**October 12, 2005**

**MEMORANDUM**

**UTAH DEPARTMENT OF TRANSPORTATION**

**SUBJECT:** Standards Committee Meeting Minutes and Next Meeting

Specification/Drawing/Item Title: BA 4D W-Beam Guardrail Anchor Type 1

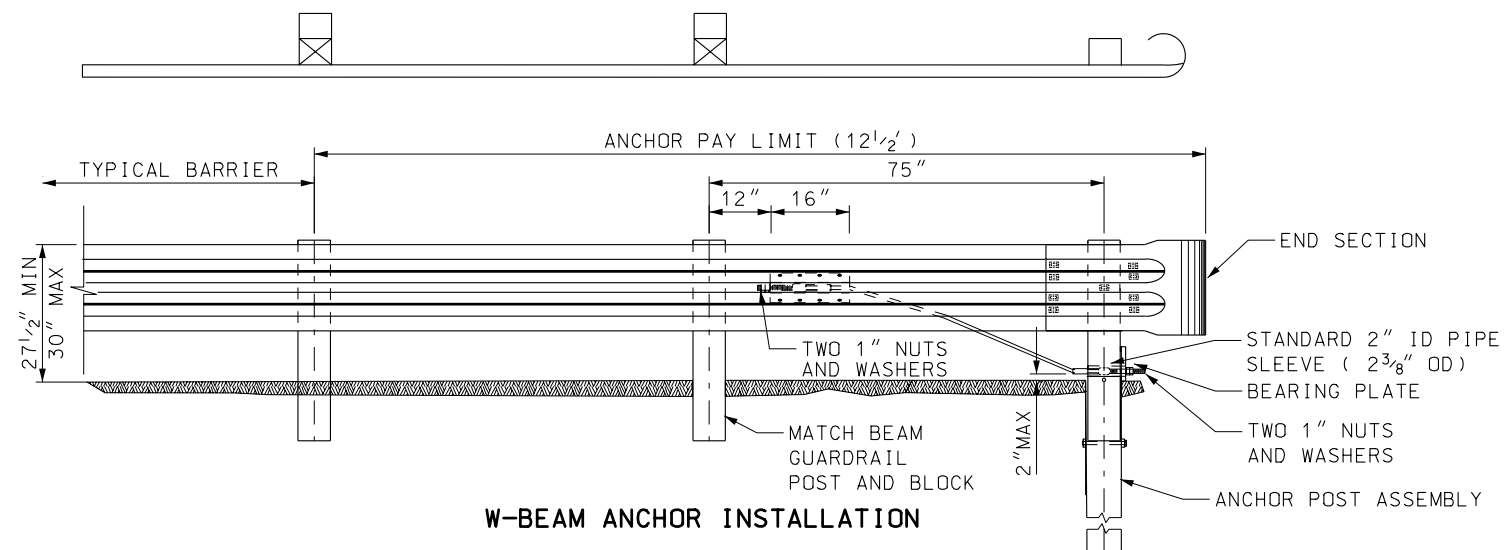
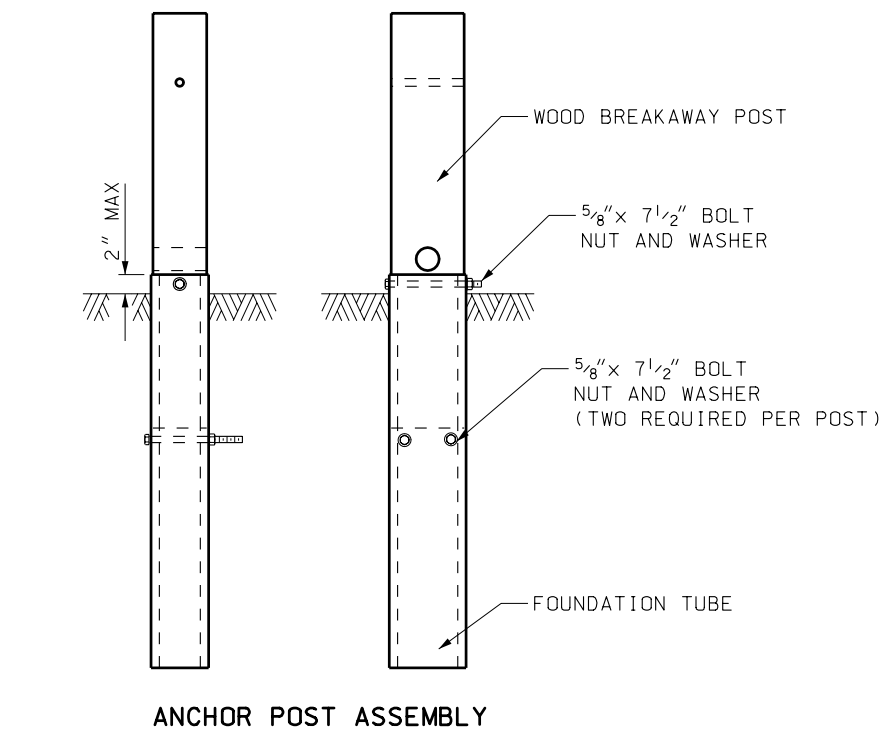
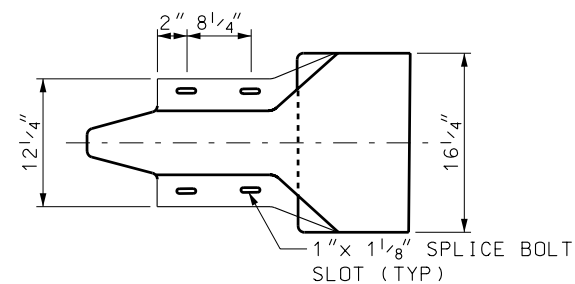
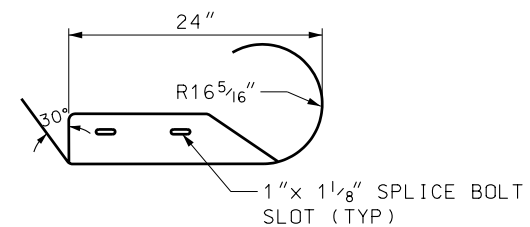
Revision 2: Installation detail, revised to match the pay item description.

Originally approved to provide tension to w-beam barrier system, original design required the soil plate, based on testing and real world experiences the plate proved not to be of great value, the post tube provided sufficient resistance to allow the w-beam to go into tension upon impact.

NOTE:  
INSTALL BEARING PLATE WITH 5"  
PORTION UP. SECURE PLATE TO  
POST USING TWO NAILS AT TOP  
OF PLATE.

<b>REVISIONS</b>					
<b>ID.</b>	<b>DATE</b>	<b>APPR.</b>	<b>REMARKS</b>		
1	10/27/05	GS	REMOVED SOIL PLATE REQUIREMENT. REVISED W-BEAM ANCHOR INSTALLATION DETAIL-REVISED DIMENSIONS ON BREAKAWAY POST AND FOUNDATION TUBE.
